City of Biddeford
Planning Board
August 16, 2023 6:00 PM City Hall
Council Chambers, & Zoom
<https://biddeford.zoom.us/j/94983531202?pwd=Q3ZyejcyUVpBaUVVMHduYXJhSzB4UT09>
Webinar ID 949 8353 1202; Passcode 223739

- 7. NEW BUSINESS**
 - 7.A. 2023.29 Public Meeting and take comments regarding Phase I of a Preliminary Subdivision Plan Application for One Diamond Development, LLC to construct 477 residential units, multi-unit buildings and commercial space at 1 Diamond Street (Tax Maps 40 & 37, Lots 25-1,25-2,24,25,34 & 35) in the B1 & GD1 and in the shoreland overlay zone.

[2023.29 One Diamond Master Plan and Phase 1 PRELIMINARY PLAN Planners Report 2 8-10-23.pdf](#)
[One Diamond Site Plan Application Materials 2023-06-14 18462.pdf](#)
[One Diamond - Full Plan Set to City of Biddeford 2023-06-14 18462_Reduced \(2\).pdf](#)
[2023-08-01_Diamond Match Phase 1 Preliminary Submittal - PW Comments.pdf](#)
[Response to Public Works Comments recieved 08-03-2023.pdf](#)
[Galbraith 08-10-23.pdf](#)
[One Diamond SLODA 2023-06-14 18462.pdf](#)

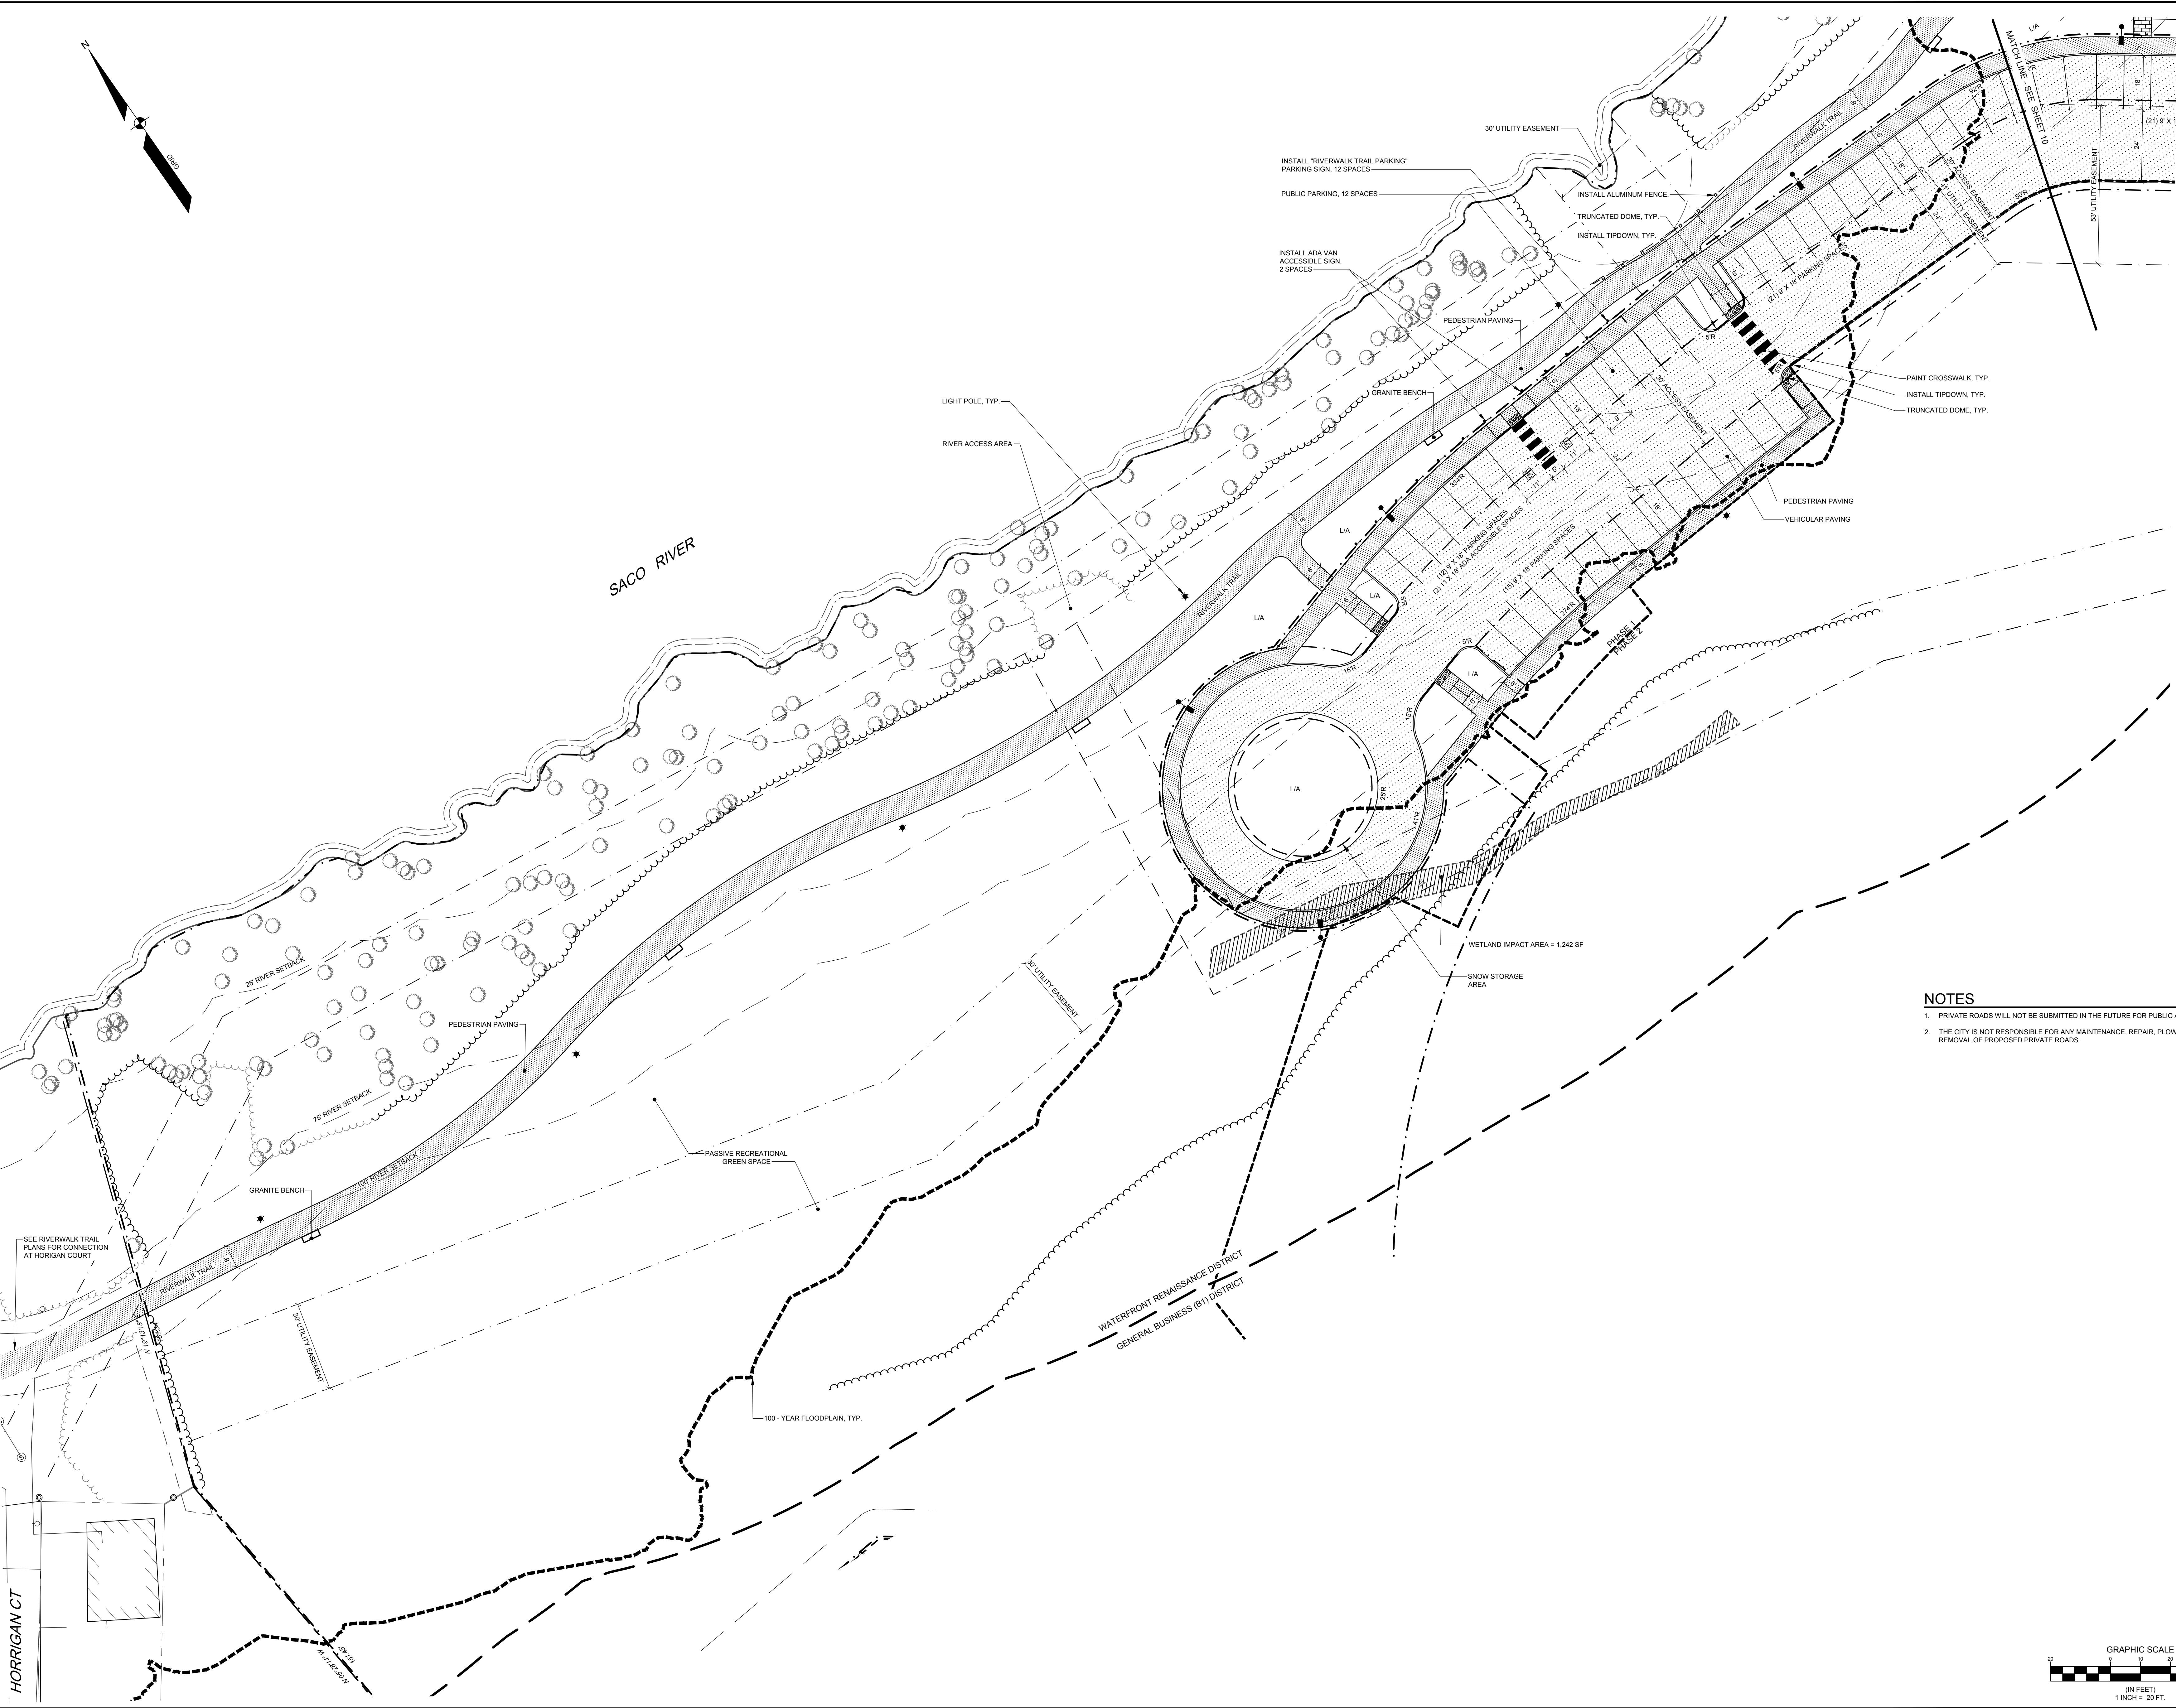
- b. Only 27 sheets submitted; cover sheet lists 51+
3. Sheet 9 – Site Plan
 - a. Will private parking be enforced or will public be able to utilize surface parking spaces (i.e. Riverwalk)?

6. *Sheet 9 – Site Plan*

GRADING PLAN - PHASE 1 - AREA 1B

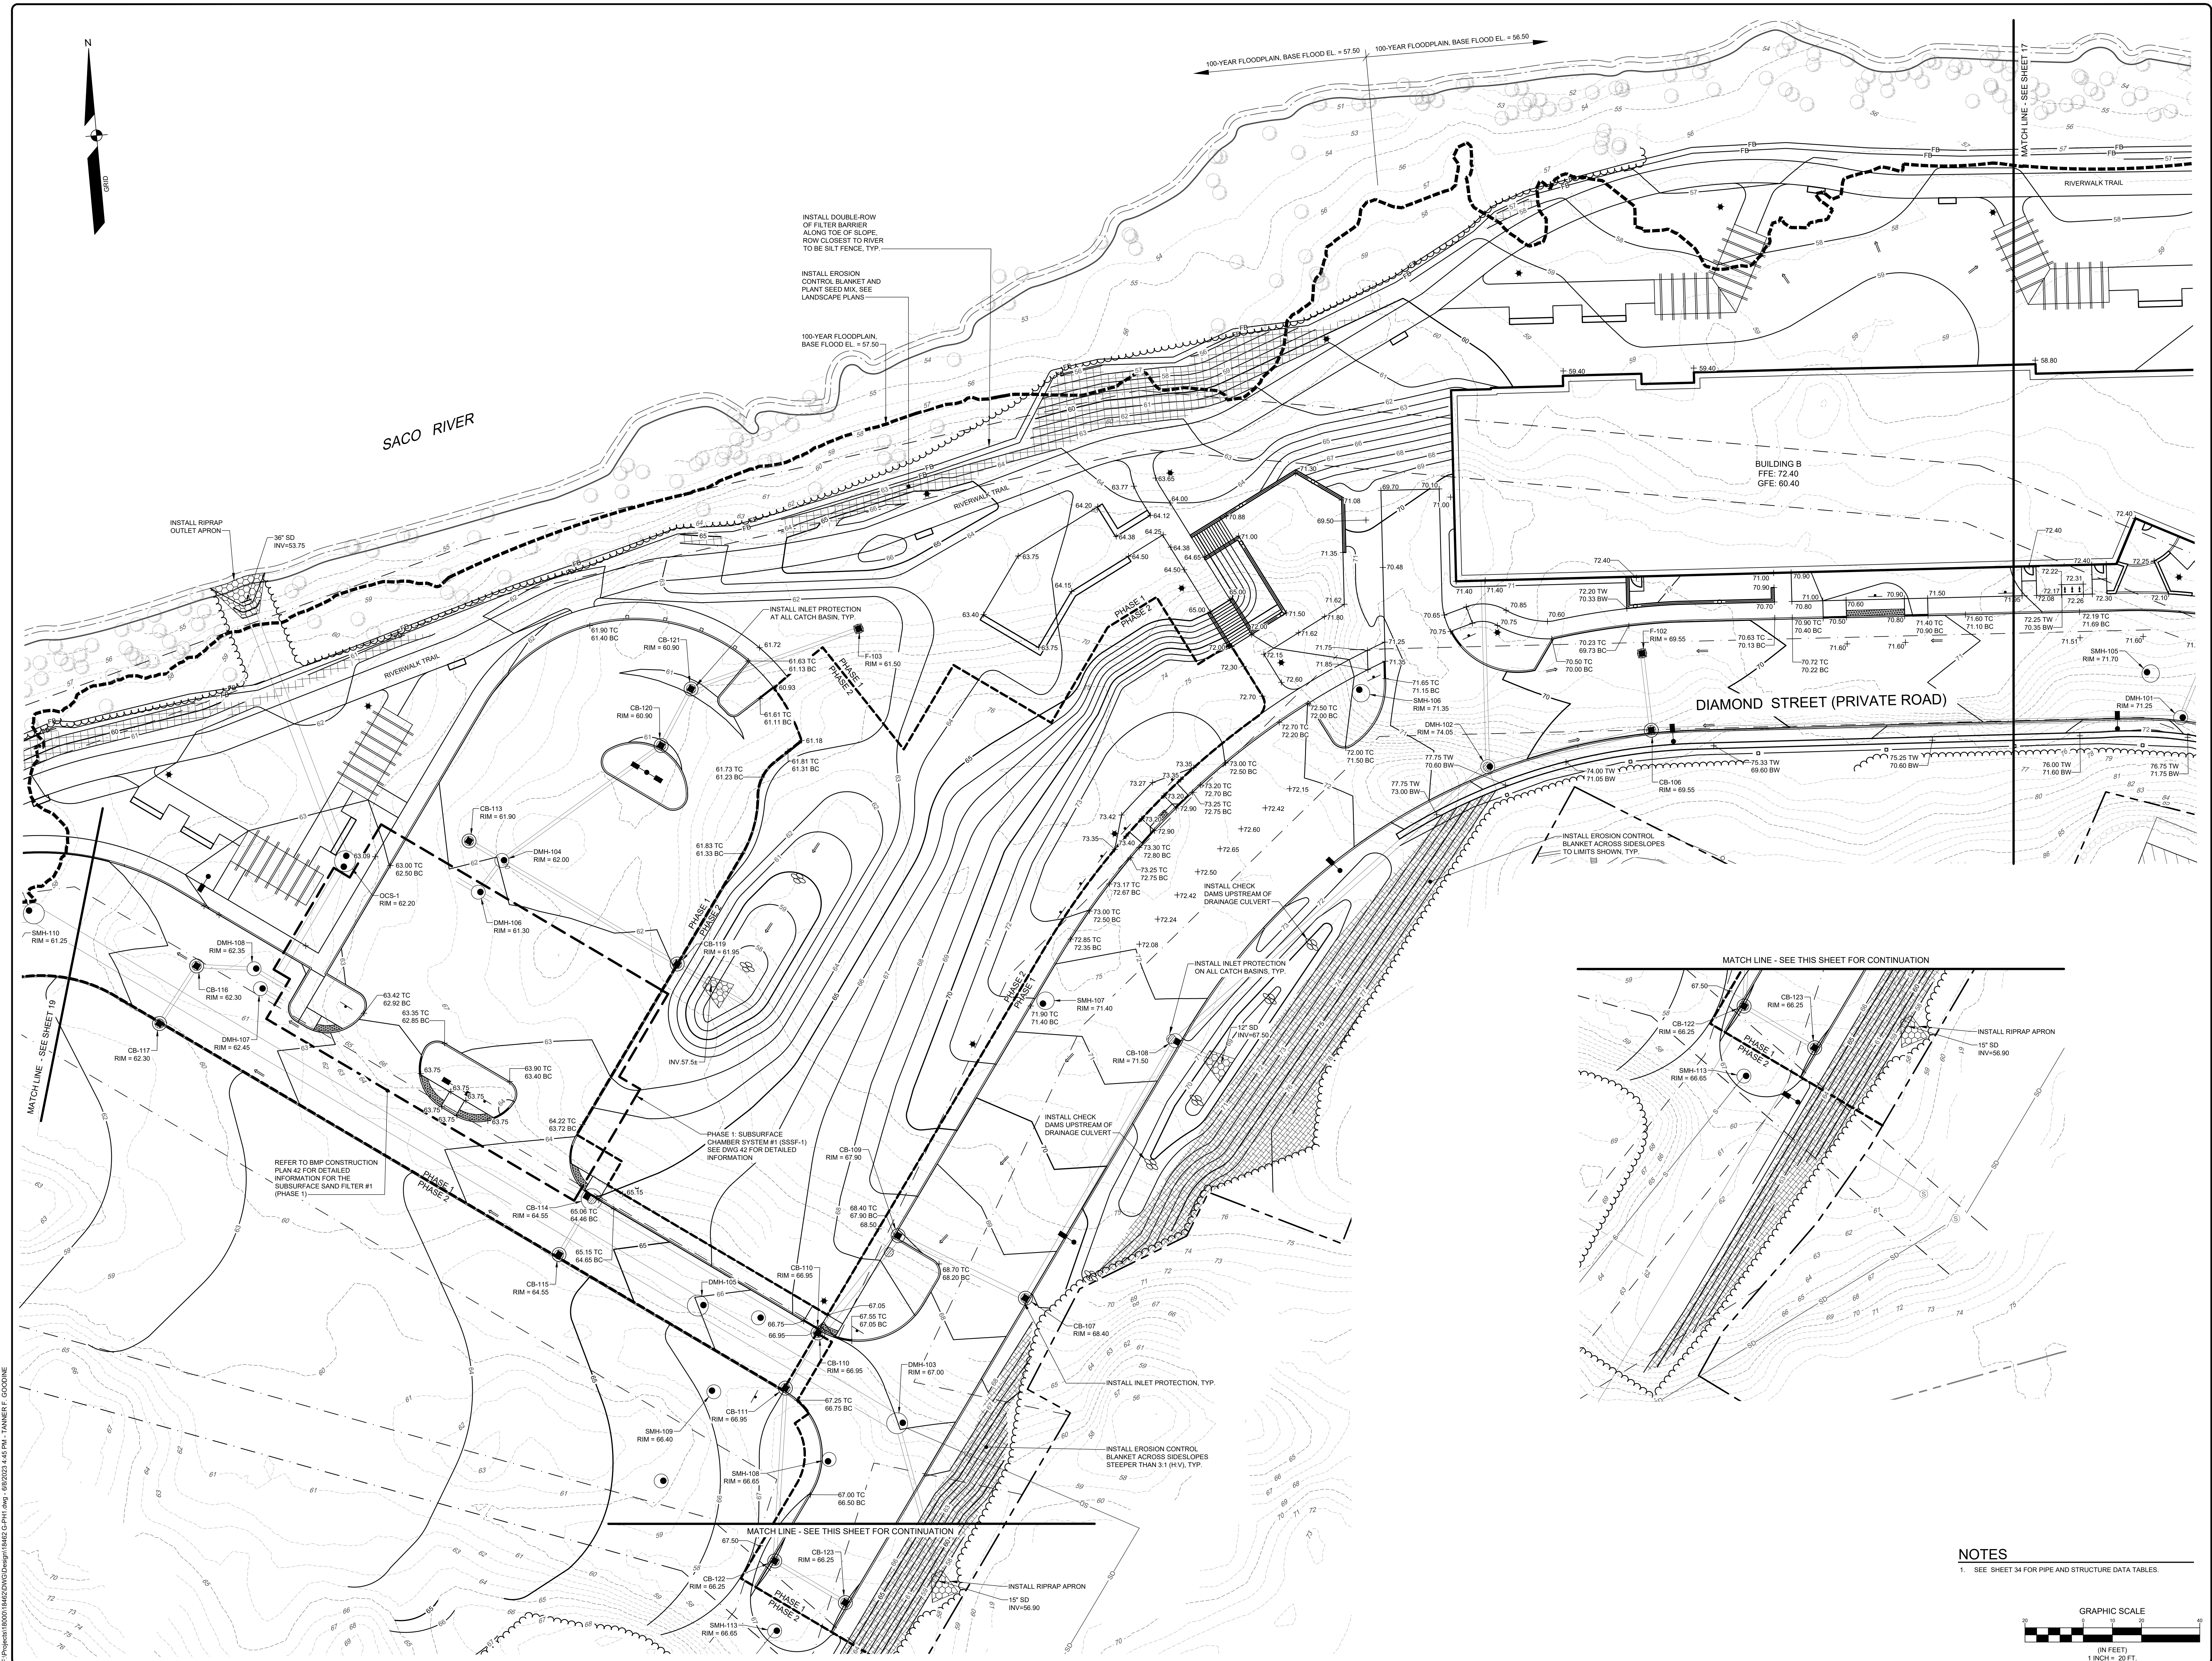
- d. Per the SWM report, post-drainage flows to the existing Elm Street storm drain are being doubled (5-cfs vs 9.3-cfs)
8. Sheet 18 – Grading Plan
 - a. Tough to understand drainage routing without having drainage/utility plans
